PLANNING COMMISSION AGENDA

- Final Site Plan Review / C & R Garage LLC / 700 Doheny
- Downs Preliminary Site Plan Review
[Vacant parcels on the south side of Cady St. (between S. Center & Griswold), the Northville Downs racetrack property south of Cady St. (between S. Center and River Streets), and two areas on the west side of S. Center St.]

**Final Site Plan Review
For
City of Northville, Michigan**

Applicant:	C&R Garage LLC 511 W. Main St. Northville, MI 48167
Project Name:	700 Doheny Private Indoor Storage Building
Plan Date:	September 24, 2021
Latest Revision:	March 18, 2022
Location:	700 Doheny (Southeast corner of Doheny and driveway to DPW yard)
Zoning:	PR-2, Performance Regulated Industrial District No. 2
Action Requested:	Final Site Plan Approval
Required Information:	As noted within this review

Figure 1: Proposed Roundabout Configuration

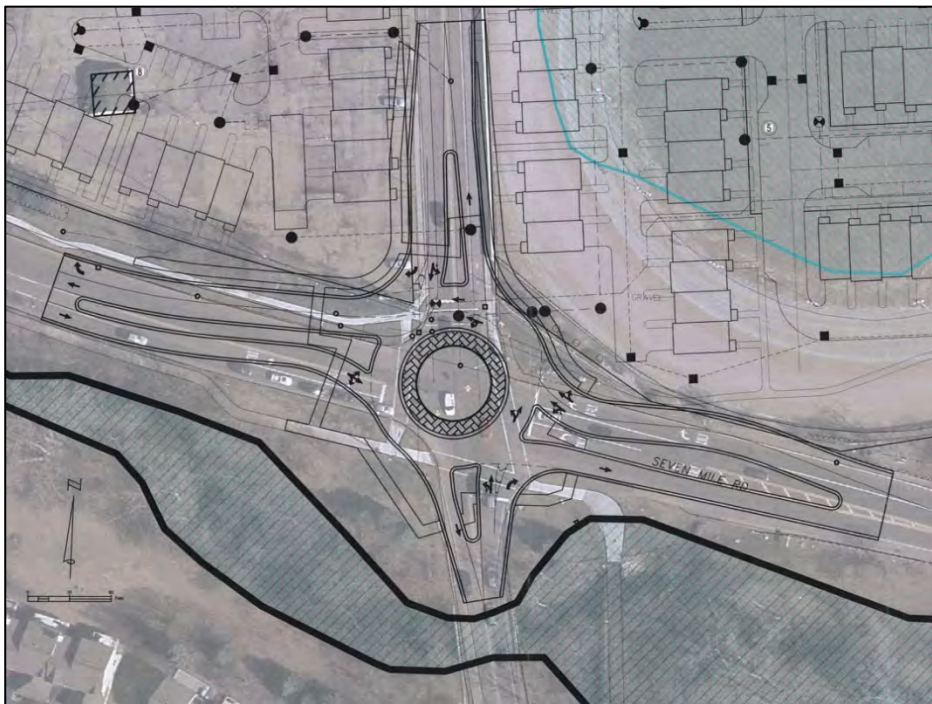
Note that the proposed geometry of the proposed roundabout has a 130' inscribed circle (outer diameter), includes large splitter islands to accommodate offset crosswalks ("zee" pedestrian paths) and large pedestrian refuge areas. The design speed for traffic circulating in the roundabout will be in the range of 15 to 20 mph. The "zee" paths allow for storage of vehicles exiting the circle that then need to stop and yield to pedestrians in the crosswalks.

Previous Site Plan Concerns

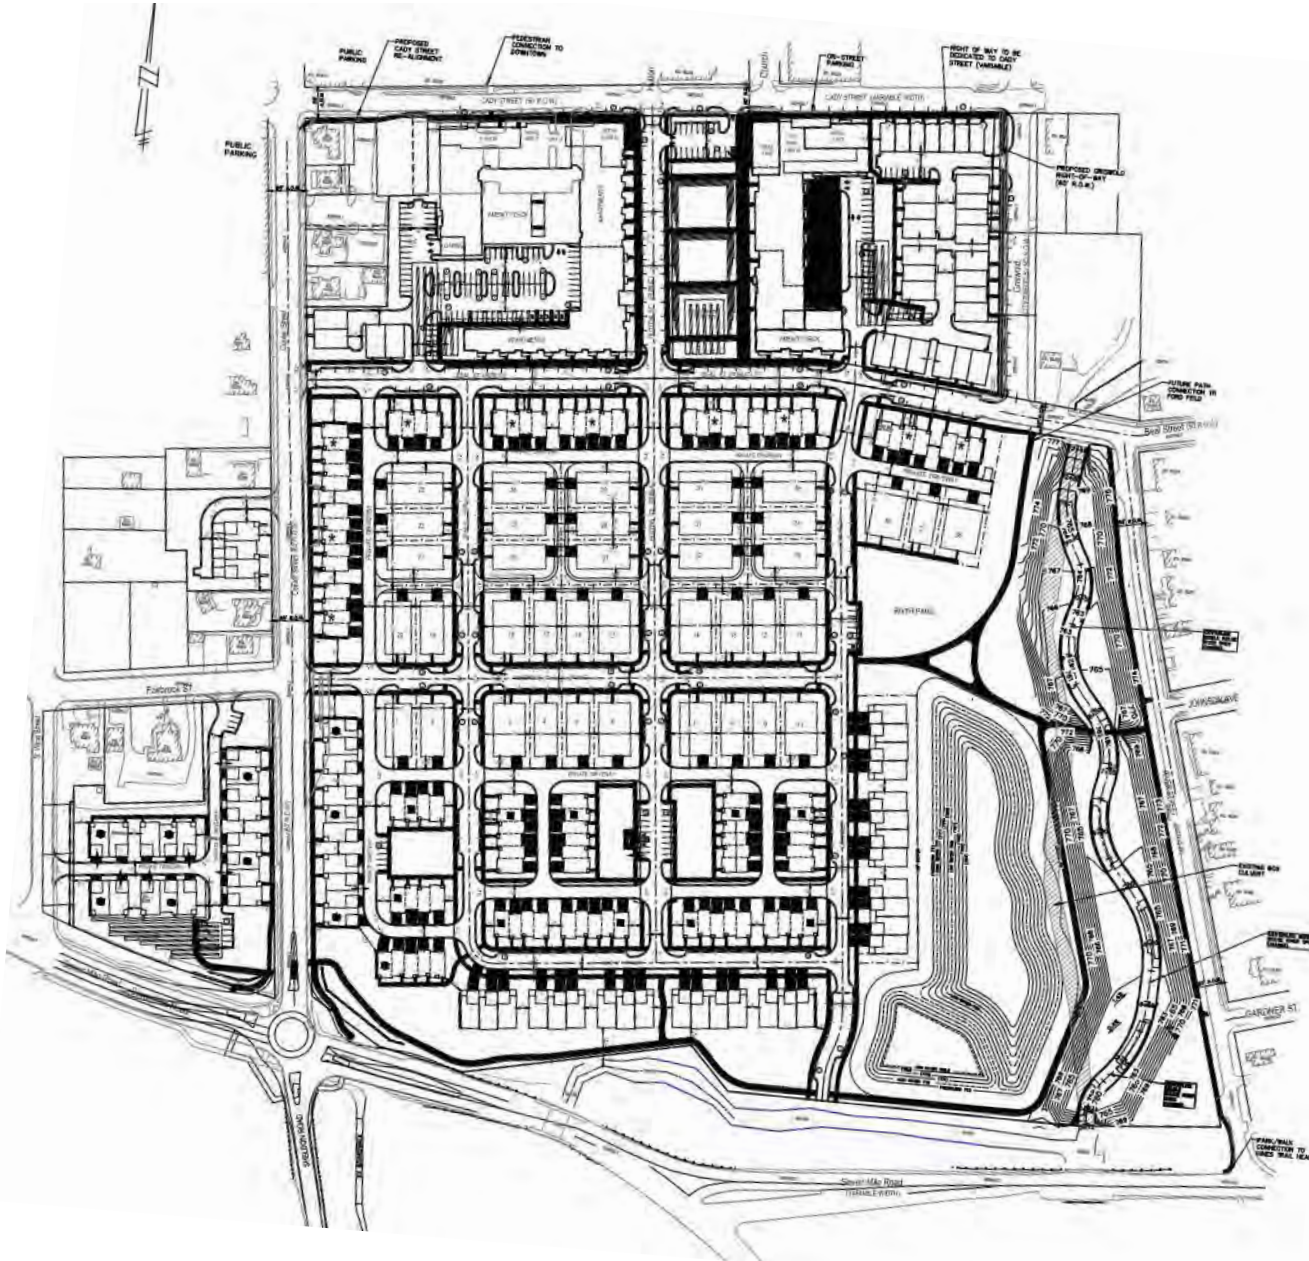
- Future access to Hines & 7 Mile per Mobility Team recommendation
- Restores the neighborhood street grid
- Multiple North/South routes
- Public roads per DPW/City request
- Parking increased with fewer private & alley roads
- Increased walkability due to reduction of ROW from 60' in many places
- Bringing Hutton south improves overall walkability
- Positive addition of pocket parks along Center Street
- Adding public roadways between the previous orphan homes increases walkability
- Like the row homes on Center vs. single family homes
- Carriage home rendering shows street trees

New Site Plan Impacts

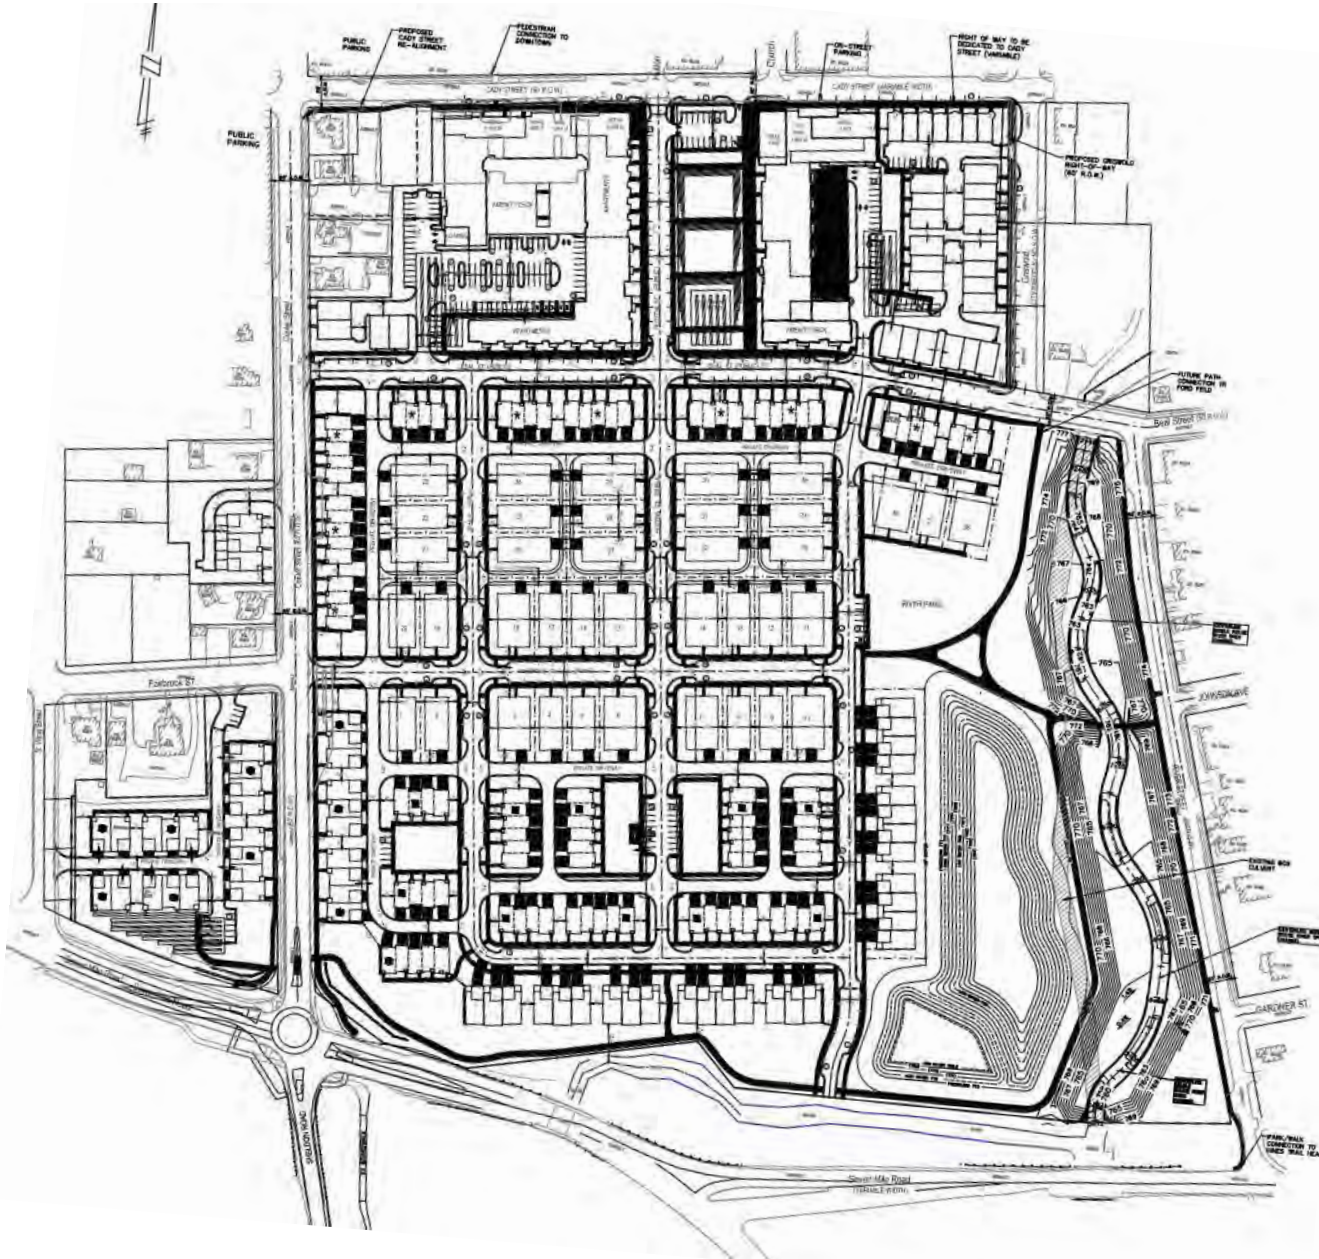
- Increased impervious surfaces (recommend exploring green infrastructure such as storm trees)
- Increased segregation of building types south of Fairbrock ~ townhomes replaced row homes
- Extensive use of bump-outs to achieve ROW section is incompatible with typical neighborhoods.
- Parking spaces on the three southern parks significantly reduces the enjoyment of the space and the likelihood that they will be welcoming to residents
- Parking on the river park ~ better to be consistent with parallel along the route instead of lot style parking
- Lack of parking along the carriage homes
- What are the number of lanes at the roundabout? We are advocating for a single lane roundabout
- Townhomes at south break visual line of carriage homes across entry gateway

Sidewalk/Buffer/Bump-out ~ Not Typical In Our Neighborhoods

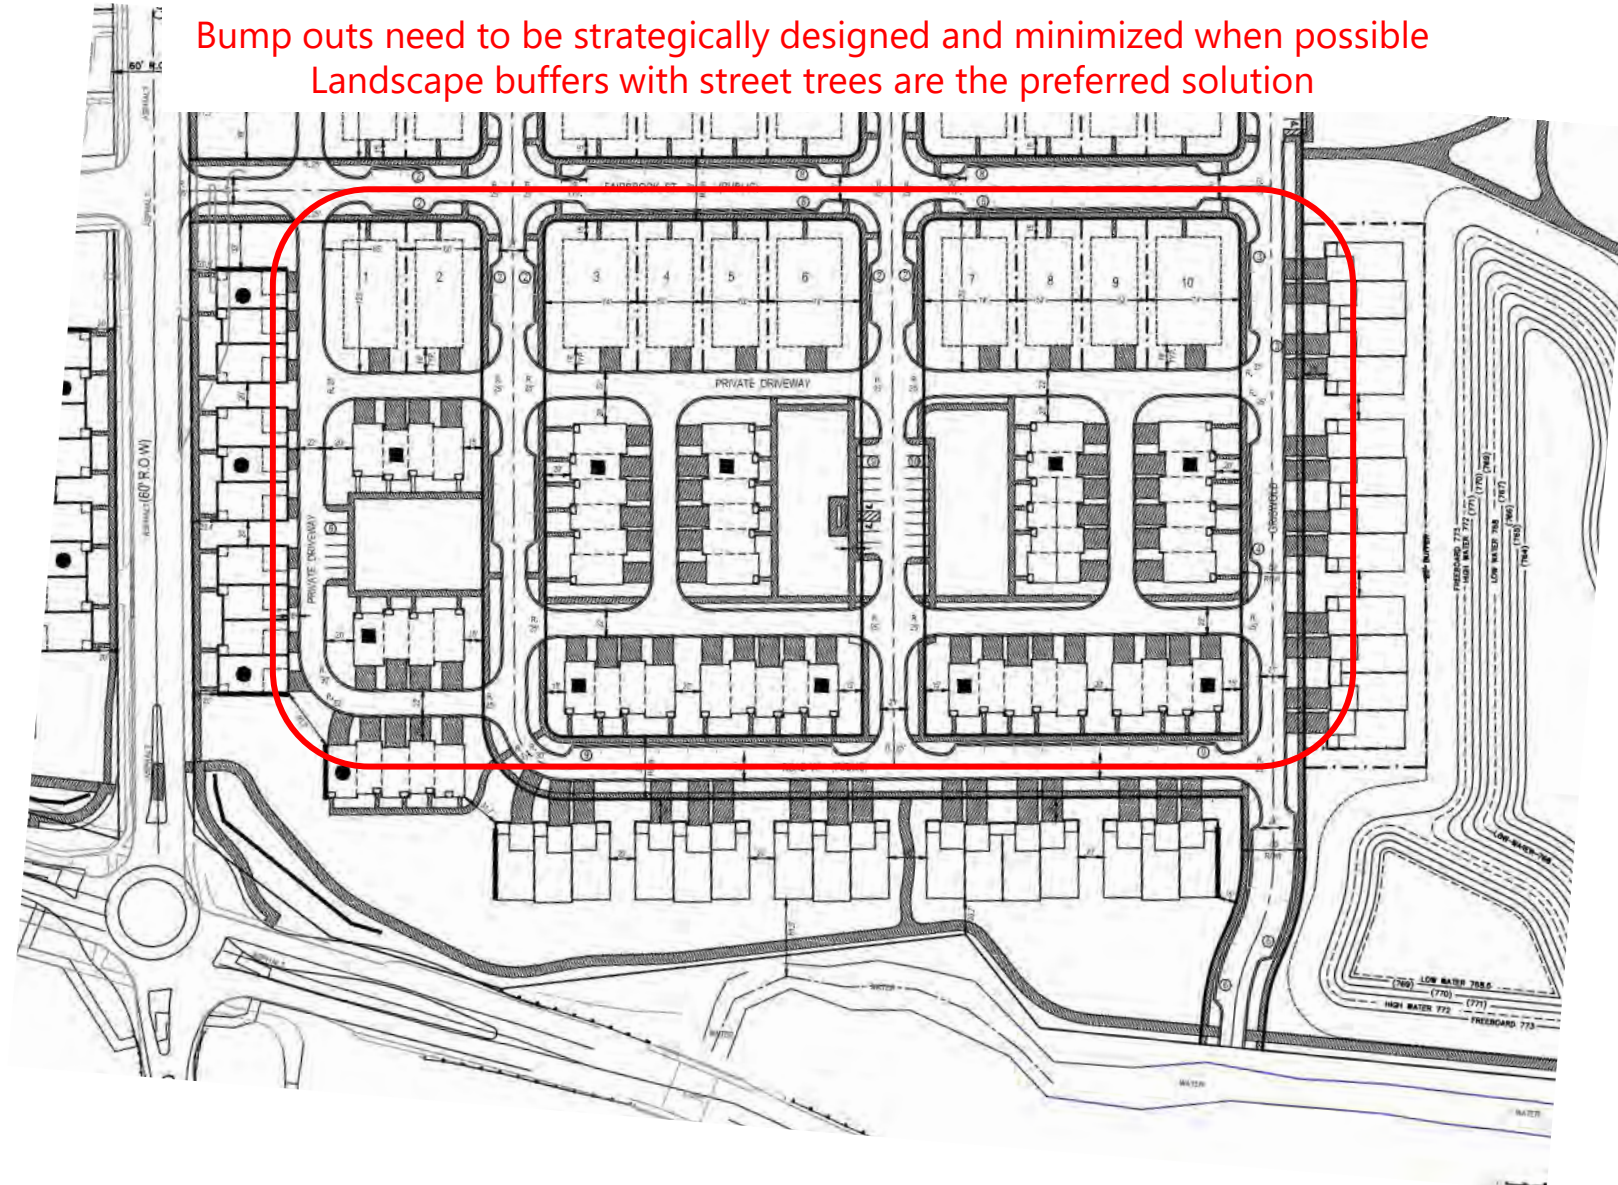
Street trees in curb extensions for downtown but not residential

Treatment of sidewalk and buffer is not consistent with site plan

Bump outs need to be strategically designed and minimized when possible
Landscape buffers with street trees are the preferred solution
